## **Traffic Calming (Speed Humps) - Scarborough Golf Club Road from Kingston Road to Hill Crescent / Guildcrest Drive**

**Date:** April 8, 2026

**From:** Acting Deputy General Manager, Transportation Services

Attachment 2: Speed Hump Locations Plan - Scarborough Golf Club Road

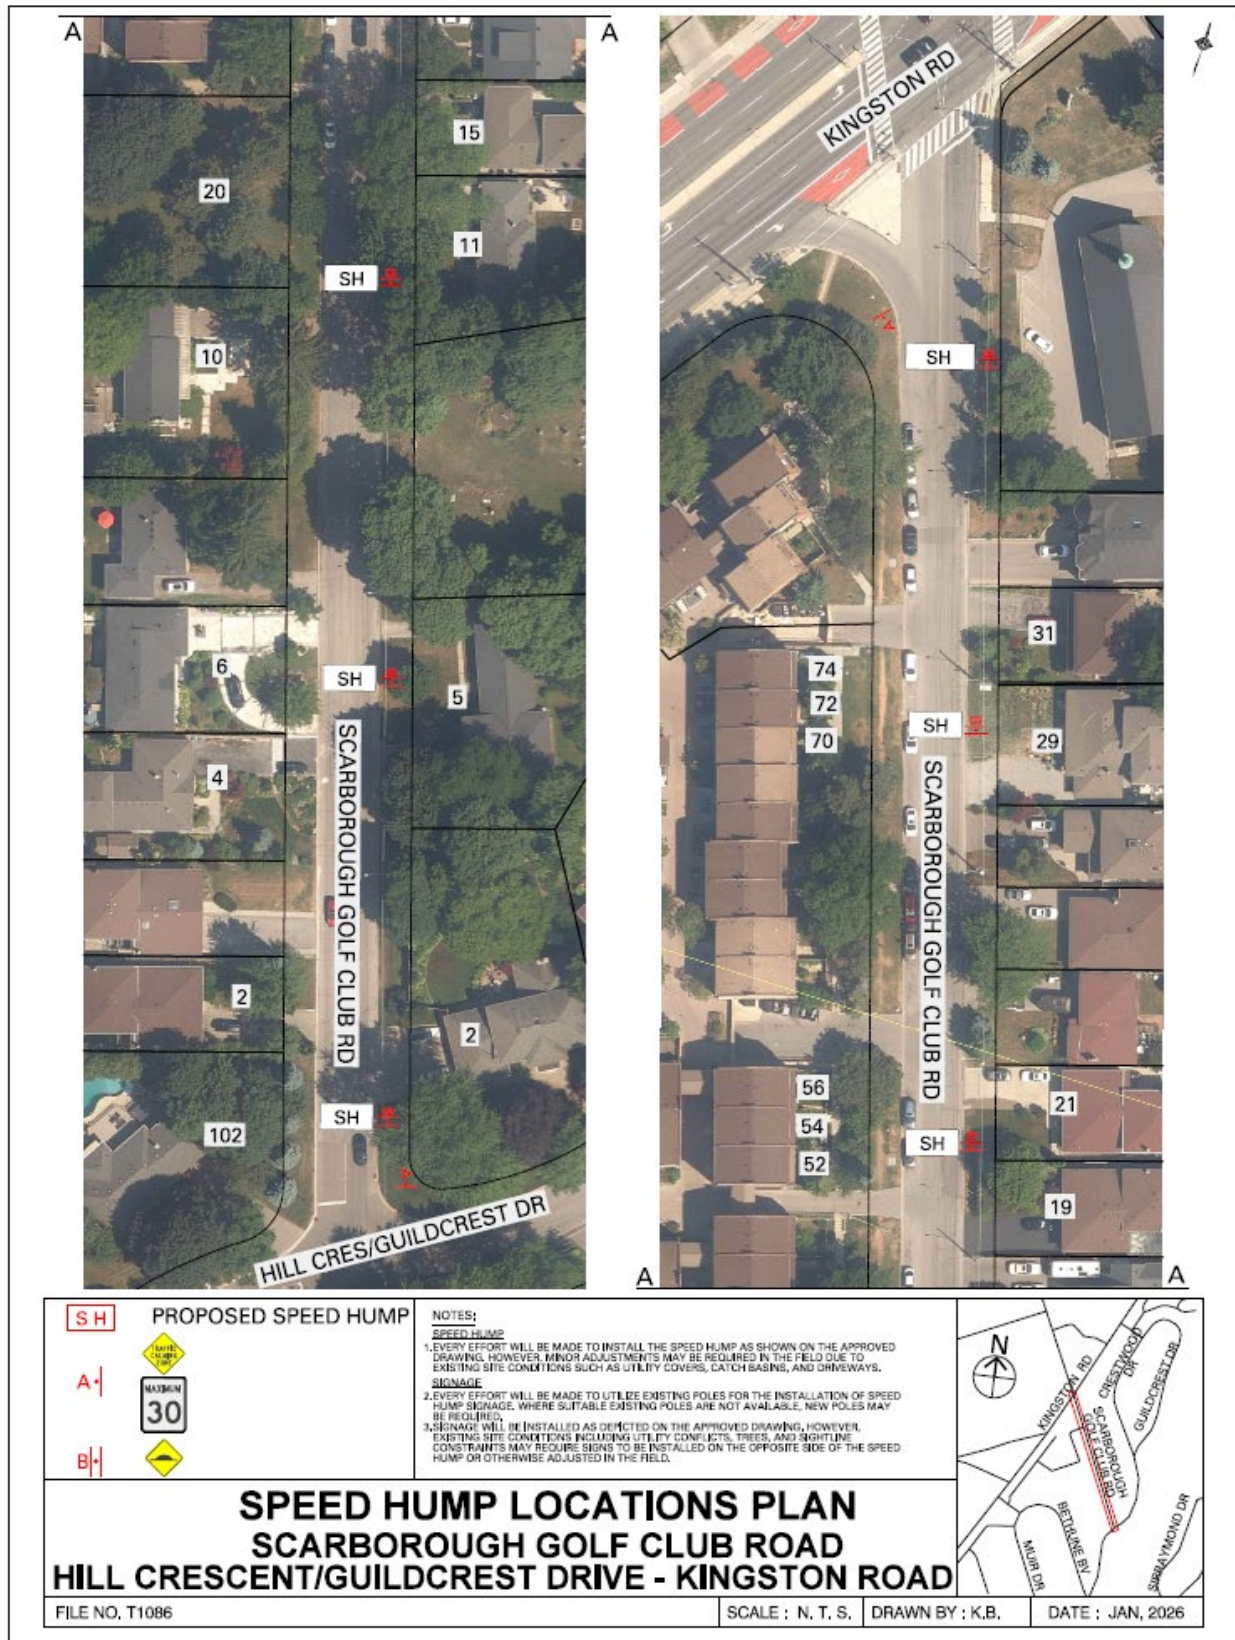
We have received and reviewed the proposal for installation of speed humps on the indicated roads in Ward 24, with the following comments:

The installation of speed humps on the indicated roads in Ward 24, will impact response and transport times for residents that reside on the roadway speed humps are installed. Impacts may extend to community members if the indicated roads in Ward 24, serves access to other roadways. It is important that the applicant understands that the installation of traffic calming devices will reduce the speed that emergency vehicles travel when responding to emergencies on roadways where they are installed.

Toronto Paramedic Services is supportive of community initiatives that improve the safety of all citizens of, and visitors to, the City of Toronto. Traffic and pedestrian safety are key components of a healthy neighbourhood, and we endeavour to support the wishes of the community to implement measures to improve upon these components.
